Project 88-067
June 1994

NRC Request for Information

**Atlas Corporation Reclamation Plan
Uranium Mill and Tailings
Disposal Area**

**RESPONSE TO NUCLEAR REGULATORY COMMISSION
REQUESTS FOR INFORMATION
NOVEMBER 29, 1993
ENCLOSURE 1 - FAULTING, SEISMIC
AND GEOMORPHIC CONSIDERATIONS
ENCLOSURE 2 - OTHER CONSIDERATIONS
JANUARY 3, 1994
ADDITIONAL QUESTIONS AND COMMENTS
SURFACE WATER HYDROLOGY AND EROSION PROTECTION
RECLAMATION PLAN
URANIUM MILL TAILINGS SITE
MOAB, UTAH**

GENERALIZED CROSS SECTION ATLAS RECLAIMED TAILINGS IMPOUNDMENT STABILITY ANALYSIS

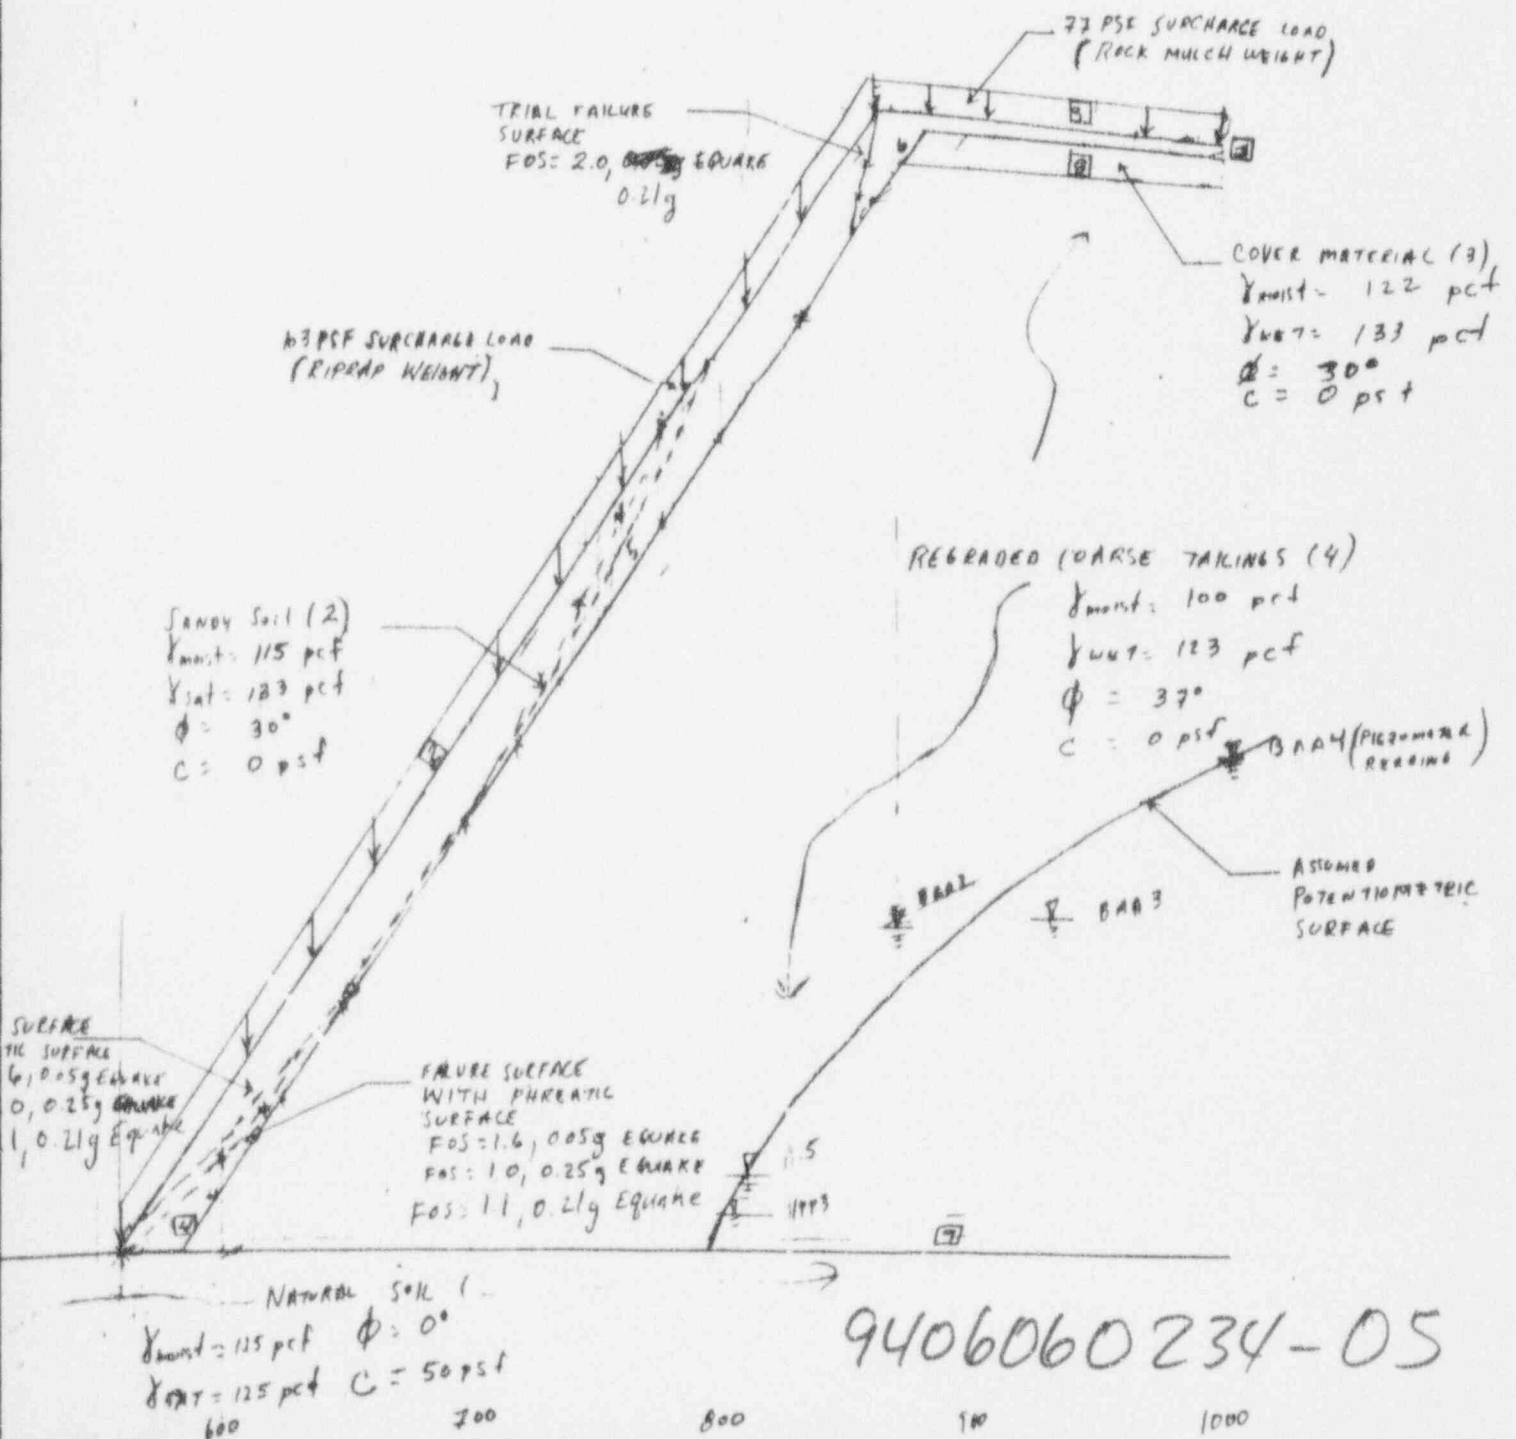
Comment

Dewatering of the existing tailings pile is currently ongoing. In the event that water is present in the tailings a phreatic surface is assumed for Scenarios 2, 4, 5, and 7 as a short term condition. The phreatic surface is assumed based on water level readings in piezometers at the tailings pile recorded on October 30, 1993, and provided to Canonie by Atlas Corporation (Atlas). Using the piezometers nearest the critical cross section, the phreatic surface has been extrapolated on Figure 1.

Failure surfaces predicted by PCSTABLE5 for the scenarios listed above are shown graphically on Figure 1. Soil properties and strength properties used in the analysis are also presented on Figure 1. Details of the stability evaluation are provided in Appendix A. Appendix A also contains the piezometer coordinates and the most current water level information.

The factor of safety against slope failure is greater than 1 for Scenarios 1, 2, and 3. For worst case Scenarios 6 and 7, the impoundment could withstand an earthquake with a horizontal earthquake acceleration of 0.25 g. This is 400 percent larger than the 250-year earthquake acceleration predicted for Moab, Utah, and 19 percent larger than the MCE loading. Based on the results of the stability analysis and the low probability of the MCE being exceeded, the reclaimed embankment design will provide an adequate factor of safety against shear failure.

88-067-E14	DATE: 4-7-93	DRAWING NUMBER
	SCALE: AS SHOWN	88-067-E66
	SHEET 4 of 10

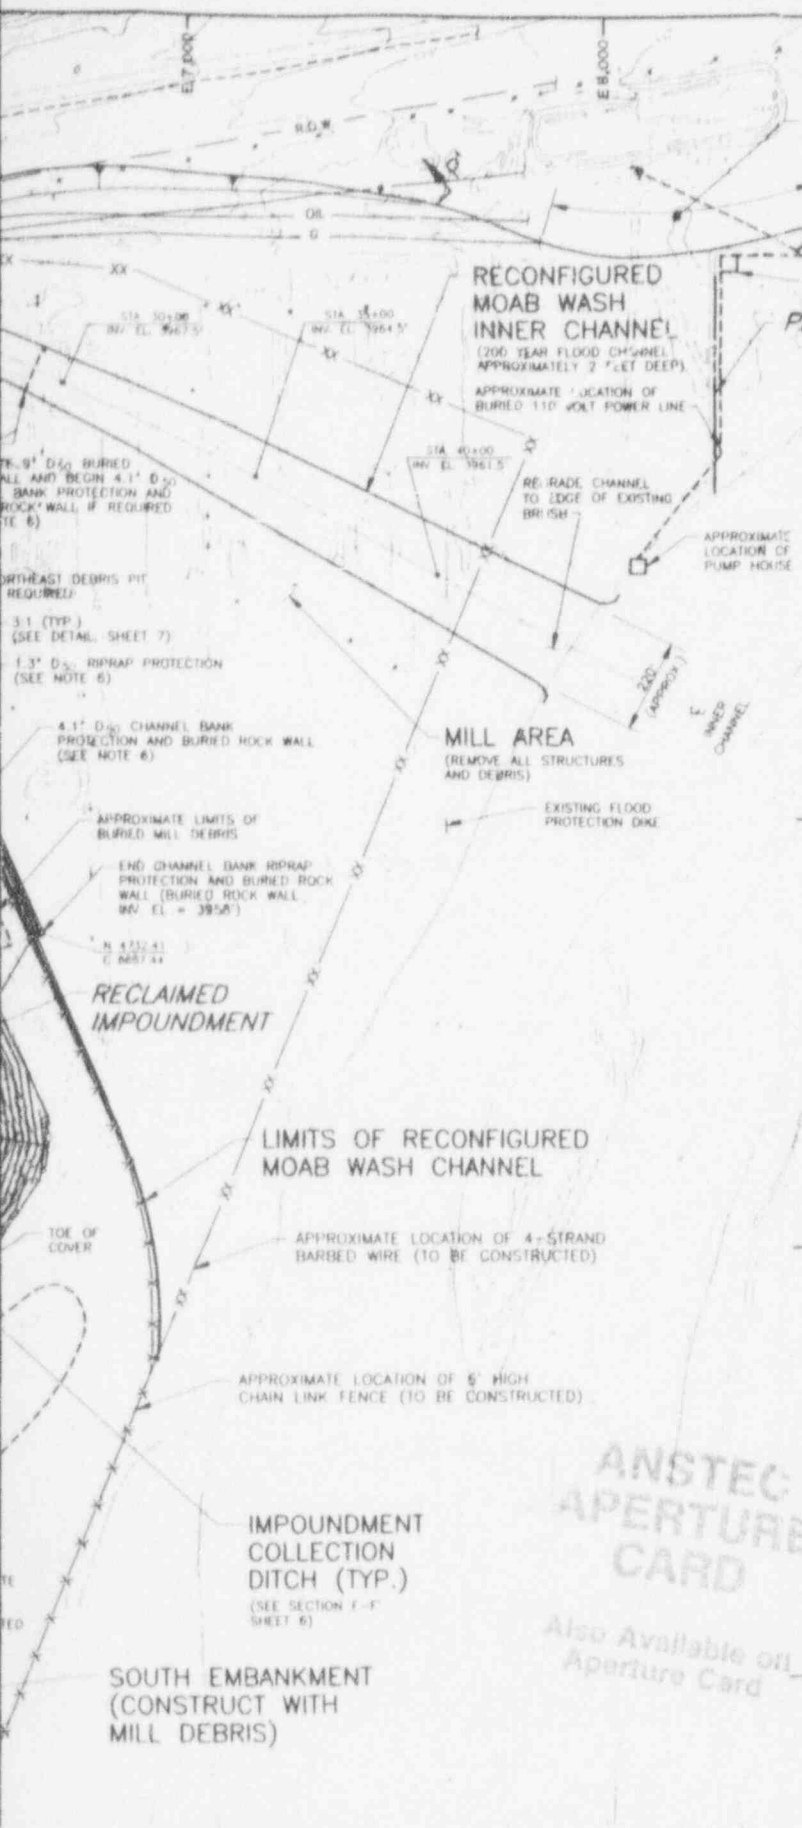
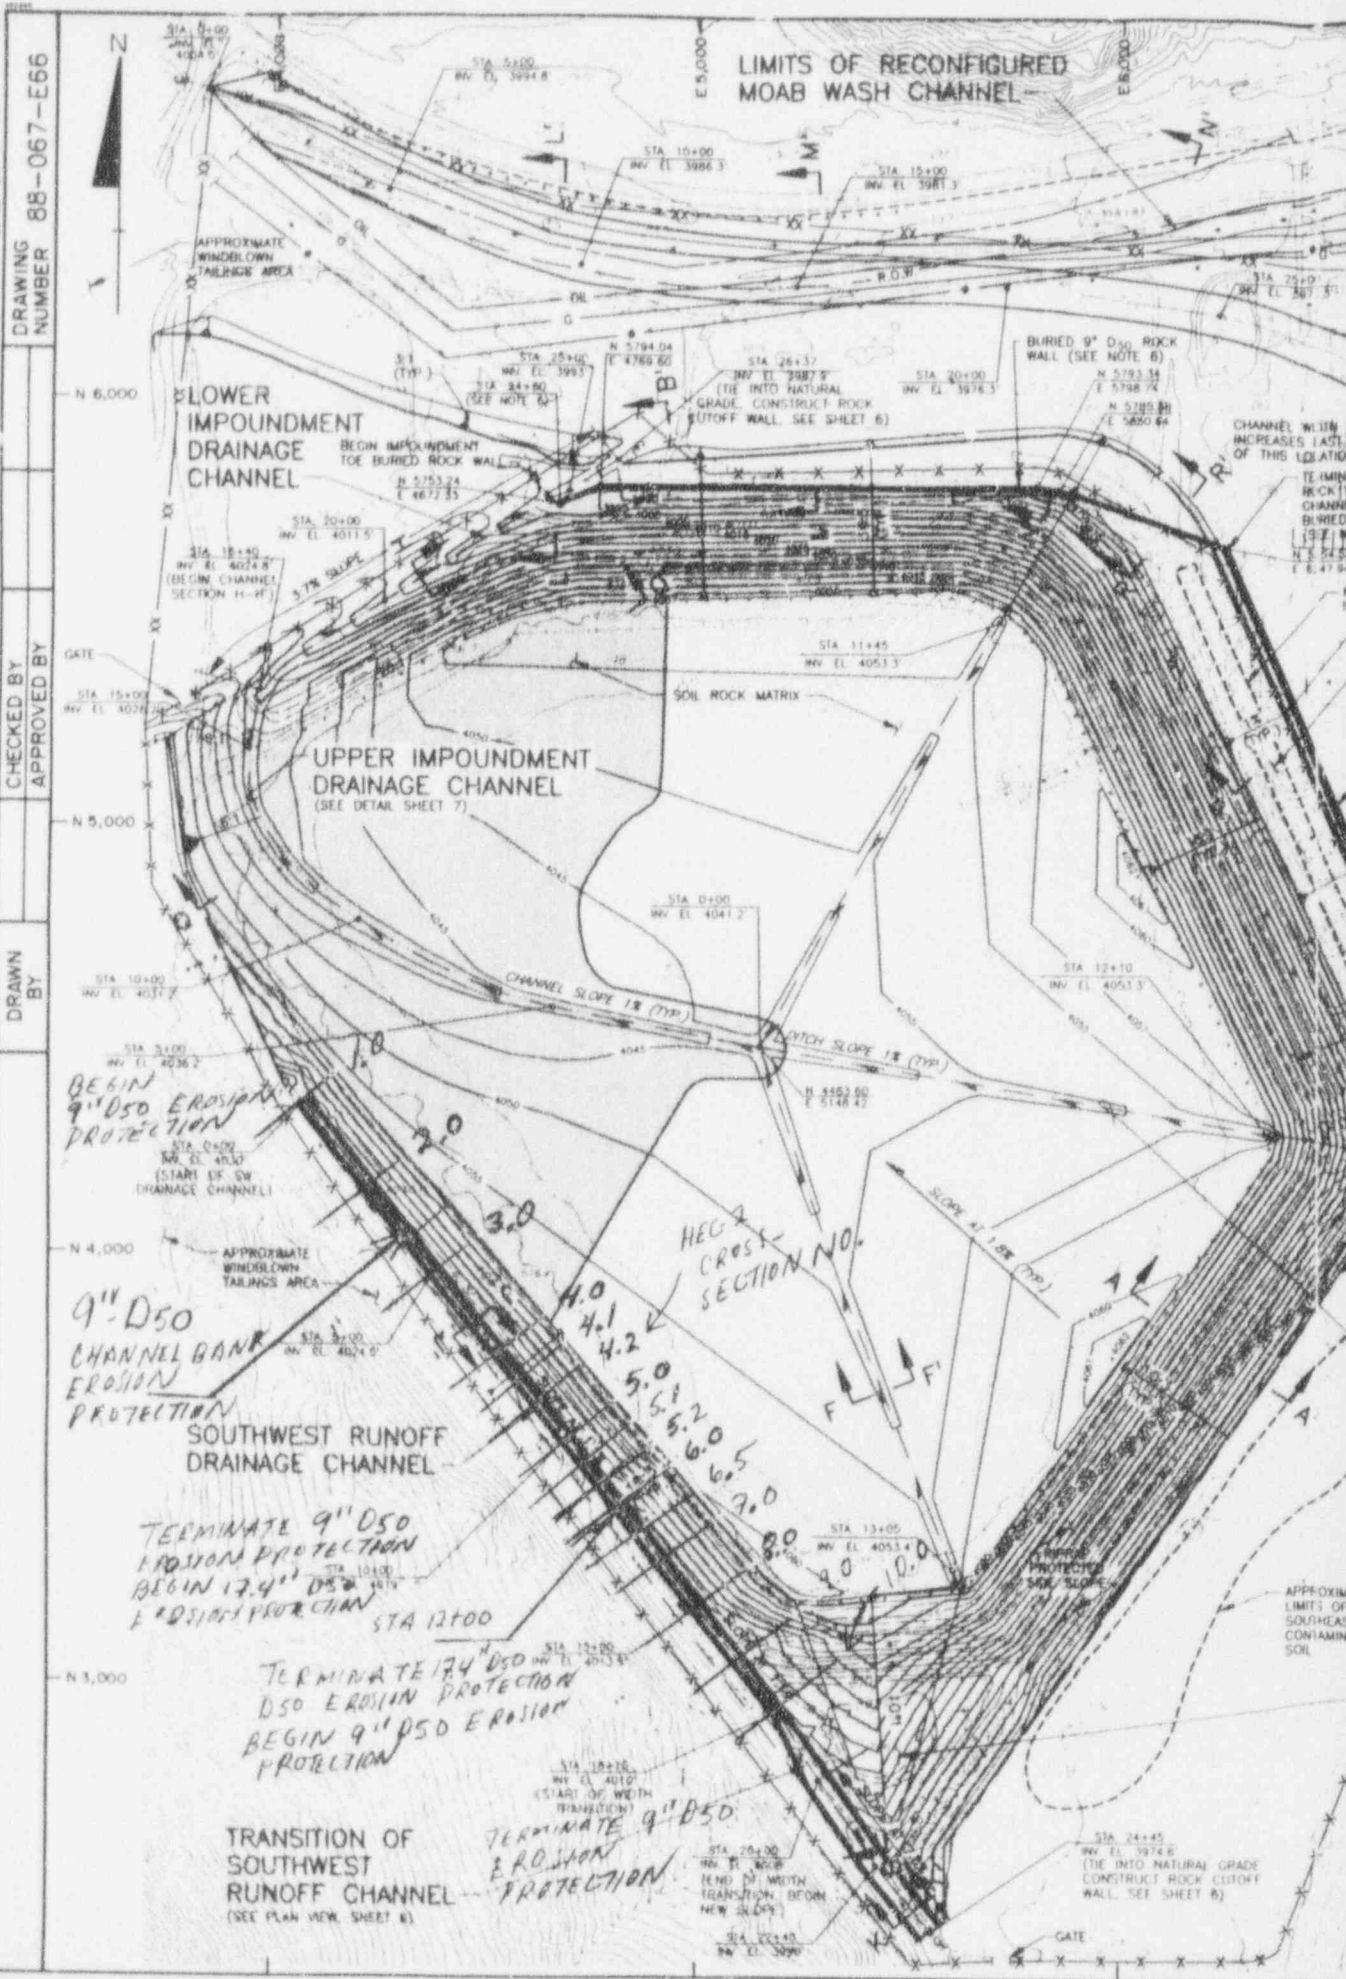
Comment

Accordingly, provide a detailed analysis to demonstrate how the drainage channels will either safely store or flush out the expected rock falls and sediment load. If your analyses conclude that the channels will safely store the expected debris load, demonstrate that changes in the water surface profiles and flow velocities will not adversely affect the stability of the riprap in the channels or on the adjacent tailings pile side slopes. If your analyses conclude that channel velocities will naturally flush out the expected sediment and large rocks, you should demonstrate that flow velocities in the drainage channels will be high enough to accomplish this for a range of flood events.

revised to accommodate the increased water surface elevations and velocities caused by these blockages. One possible design solution you may want to consider would be to eliminate the Southwest Drainage Channel and design the erosion protection on the tailings pile side slopes, assuming that large amounts of sediments and rocks are transported to areas immediately adjacent to the side slopes.

the natural drainage channel. Sheet 4 of 10 and Sheet 6 of 10 of the Reclamation Plan drawings have been revised to reflect the design changes to the SWRDC. These figures are included in the Figures section of this document. Appendix B of this document contains a detailed analysis on the redesign of the erosion protection on the tailings pile side slopes.

Sheet 4 of 10 of the drawings identifies the selected D_{50} riprap erosion protection and the location of the riprap erosion protection along the base of the tailings pile adjacent to the natural SWRDC. An actual (oversized for durability) D_{50} of 9 inches has been designed for the base of the tailings pile adjacent to the SWRDC from the beginning of the SWRDC to Station 10+00 and from Station 12+00 to Station 18+15 (beginning of the width transition). From SWRDC Station 10+00 to 12+00, an actual D_{50} of 17.4 inches has been designed. These D_{50} values are sized adequately to withstand a Probable Maximum Flood (PMF) event in the natural drainage channel. Furthermore, the D_{50} values are adequately sized for flow conditions resulting from a rock fall into the channel of a reasonable volume of rocks, based on engineering judgement.

As illustrated on Sheet 4 of 10, a natural drainage way from Station 18+15 to the end of the SWRDC was not considered because existing contours adjacent to the reclaimed tailings pile do not provide for adequate drainage nor does a natural channel provide adequate protection at the outlet of the SWRDC. The designed trapezoidal channel will be used from the start of the width transition to the end of the channel including the rock cutoff wall. Rocks or sediments entering the lower reach of the SWRDC should not severely restrict drainage because the lower reach is fairly wide (50 feet) and the slope is steep (7.5 percent).
